DRAINAGE CERTIFICATION W/SURVEY WORK BY OTHERS

Car Crafters
Automotive Repair Garage
5404 Edith Blvd. NE
Albuquerque, New Mexico 87107

AS-BUILT

GRADING AND
DRAINAGE PLAN

C102A

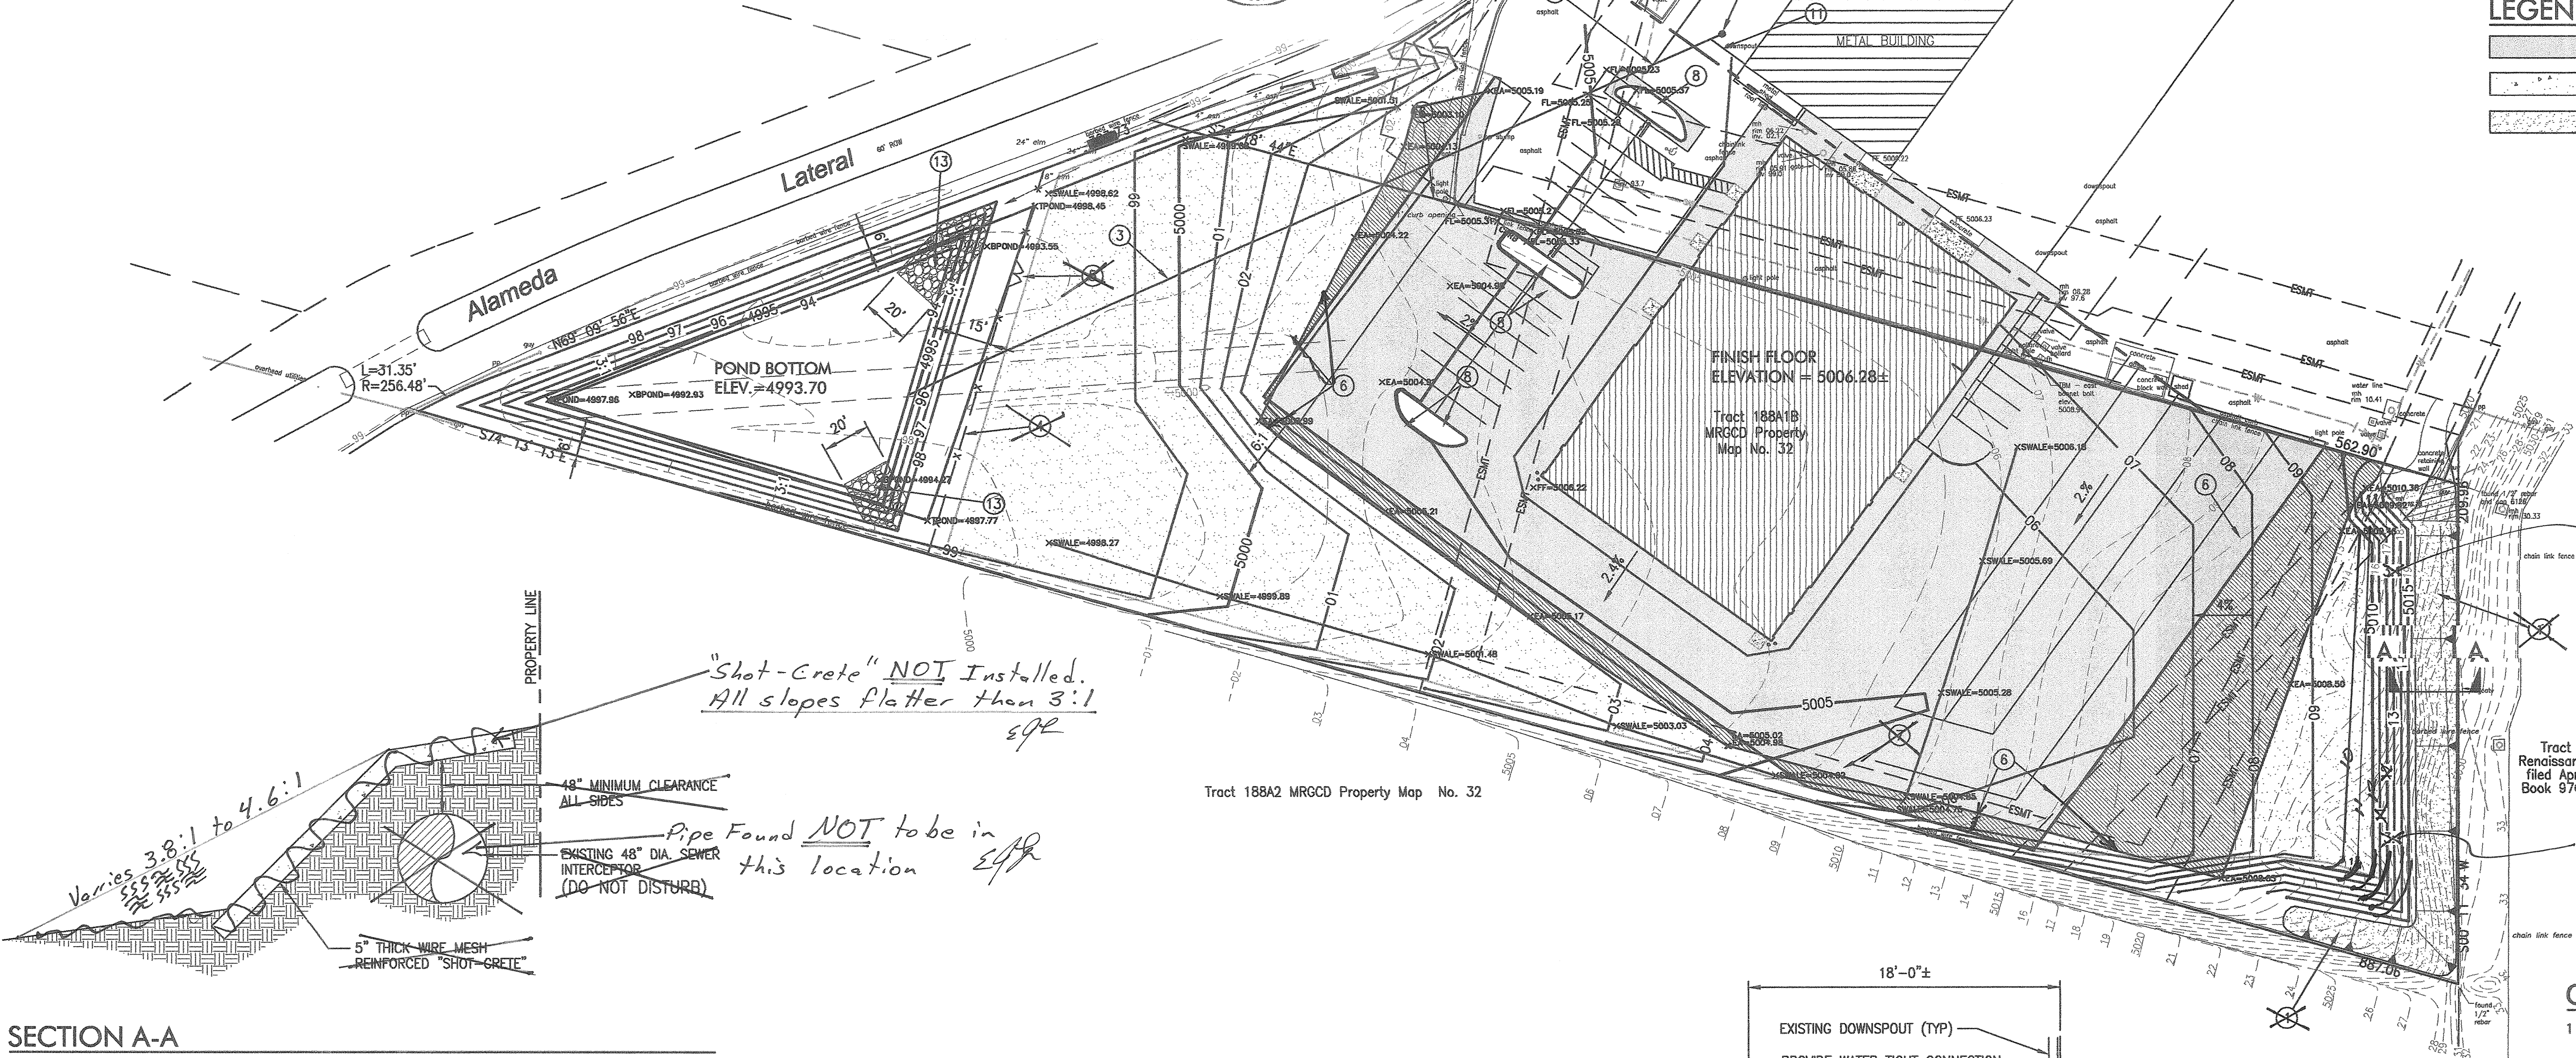
DURING THE COURSE OF CONSTRUCTION APPROXIMATELY 10,245 SQUARE FEET OF ADDITIONAL PAVEMENT WAS ADDED ABOVE THAT APPROVED ON THE ORIGINAL PLAN. THE INCREASE OF STORMWATER VOLUME TO THE WESTERLY POND IS 2,212 CUBIC FEET. THE FREEWATER SURFACE ELEVATION IN THE POND WILL INCREASE BY 0.21-FEET TO ELEVATION 4,996.45. THE TOP OF THE POND IS AT 4997.96 AS CONSTRUCTED AND AS SUCH 1.51- FEET OF FREEBOARD REMAINS IN THE POND AFTER THE 100- YEAR EVENT. POND BOTTOM ELEVATION IS 4,992.93 AS CONSTRUCTED.

- 5" THICK "SHOT-CRETE" WITH WIRE-MESH REINFORCING. SLOPE 1:1. *Not Built EJR*
- INSTALL 250 L.F. OF 12" DIA. HIGH DENSITY POLYETHYLENE (HDPE) STORM DRAIN. MINIMUM SLOPE = 0.5%.

- INSTALL 374 L.F. OF 12" DIA. HIGH DENSITY POLYETHYLENE (HDPE) STORM DRAIN. MINIMUM SLOPE = 0.5%.
- INSTALL APPROXIMATELY 170 L.F. OF FENCING TO MATCH EXISTING PERIMETER FENCING. *Not Built EJR*

- INSTALL 12" WIDE (DOUBLE 6") GATES FOR MAINTENANCE ACCESS TO PONDS. MATCH EXISTING PERIMETER FENCING. *Not Built EJR*
- INSTALL HEADER CURB FLUSH WITH ASPHALT PER COA STANDARD DETAIL 2415.

- INSTALL CONCRETE PAVING SECTION FOR TRASH DUMPSTER. SEE DETAIL THIS SHEET. *Not Built. Trash Dumpster Remains at pre-development location EJR*
- INSTALL CURB AND GUTTER TO MATCH EXISTING CURB AND GUTTER WITHIN THE CAR CRAFTERS FACILITY.
